### World Forum for Harmonization of Vehicle Regulations

#### 190th session

## **Proposal for Supplement 1 to the 04 series of amendment to UN Regulation No. 127 (Pedestrian safety)**

### **Submitted by the Working Party on Passive Safety \***

Figure 12  
Windscreen test area

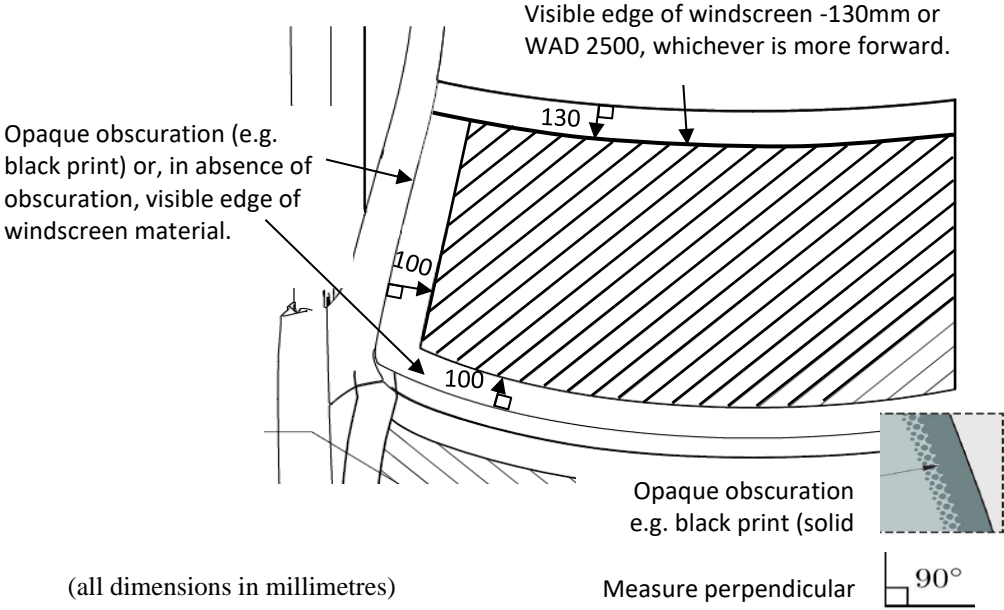
*Paragraph 2.44.*, amend to read and insert Figures 12 and 13:

"2.44. "Windscreen test area" is an area on the outer surface of the windscreen. It is bound (see figure 12):

- (a) In the front, by a line 100 mm rearward to the opaque obscuration of the windscreen. In case of absence of the opaque obscuration, the line is measured from the front visible edge of the windscreen material.
- (b) In the rear, by a WAD 2,500 or a line 130 mm forward to the rear visible edge of the windscreen material, whichever is more forward at a given lateral position.
- (c) At each side, by a line 100 mm inside the opaque obscuration of the windscreen. In case of absence of the opaque obscuration, the line is measured from the side visible edge of the windscreen material.

For (a) and (c): the distances of 100 mm are to be measured with a flexible tape held tautly along the outer surface of the vehicle at an angle of 90° to the tangent line to the opaque obscuration limit or in case of absence of the opaque obscuration, from the visible edge respectively.

For (b): the distances of 130 mm is to be measured with a flexible tape held tautly along the outer surface of the vehicle at an angle of 90 ° to the tangent line to the rear visible edge of the windscreen.

Figure 13  
Upper corner definition with "shortest distance"

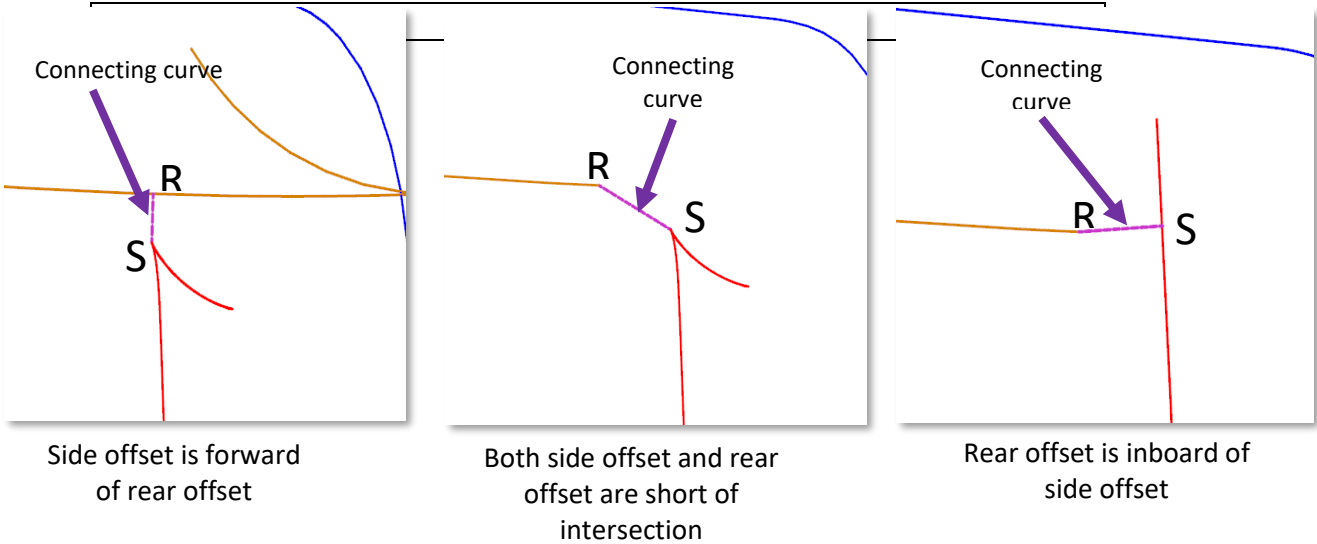
Depending on the geometry, in case there is no intersection between (b) and (c), resulting in an open test area, then the marking shall be modified using the shortest distance to close the open test area (see figure 13).

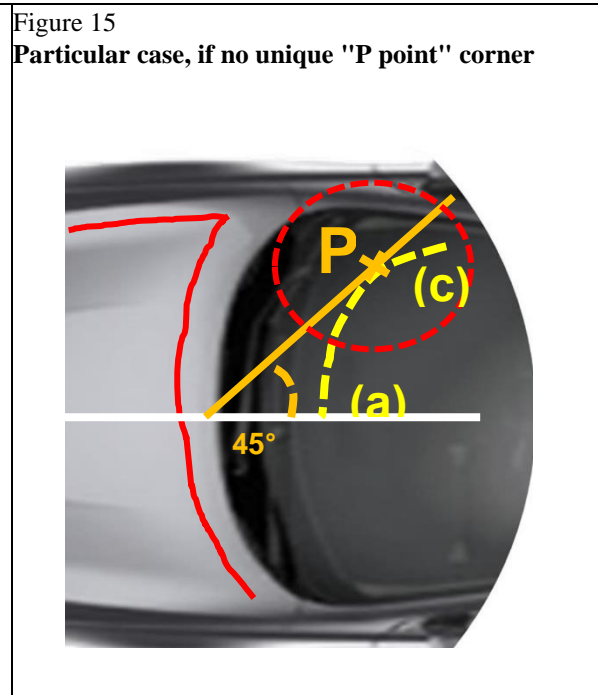
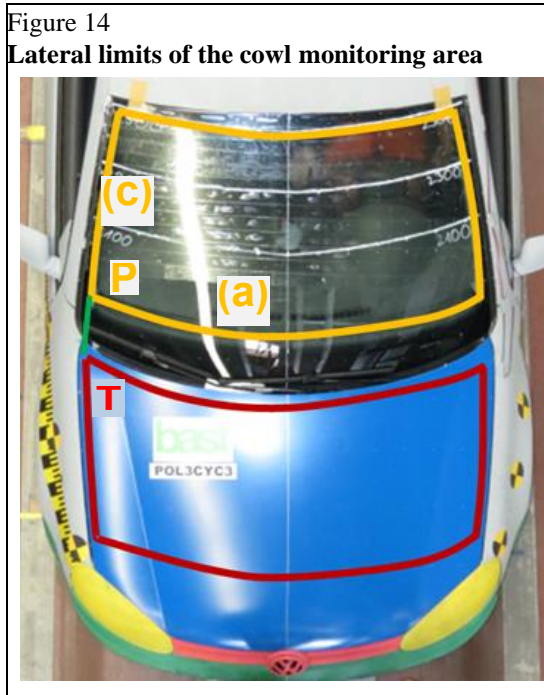
Paragraph 2.45., insert Figures 14 and 15 and amend to read:

At each side, the cowl monitoring area is bound by the TP line (see figure 14), where:

- (a) the "T point" is the rear corner of the bonnet top test area; and
- (b) the "P corner point" is the lower corner of the windscreen test area; using a flexible tape held tautly from point T to P.

If there is no unique "P point" where the lines defined in 2.44 (a) and (c) intersect, then the "P point" is defined by the first contact of a vertical plane intersecting the vertical longitudinal vehicle center-plane at an angle of 45° with the (a)-(c) transition of the windscreen test area boundary, as shown in Figure 15.

Figure 16

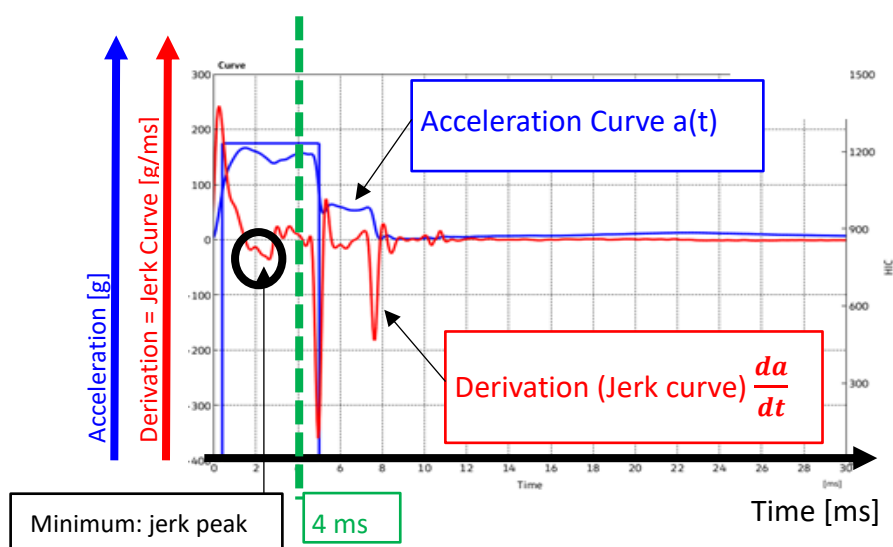
Paragraph 2.48., insert Figure 16 and amend to read:

- (a) The absolute value of the minimum value of the derivation of the headform acceleration versus time is less than 180 g/ms within the first 4 ms after the initial contact of the headform to the windscreen, as shown in Figure 16; or

$$\left| \min \left( \frac{da}{dt} \right) \right| < 180 \text{g/ms, for } 0 < t < 4 \text{ms}$$
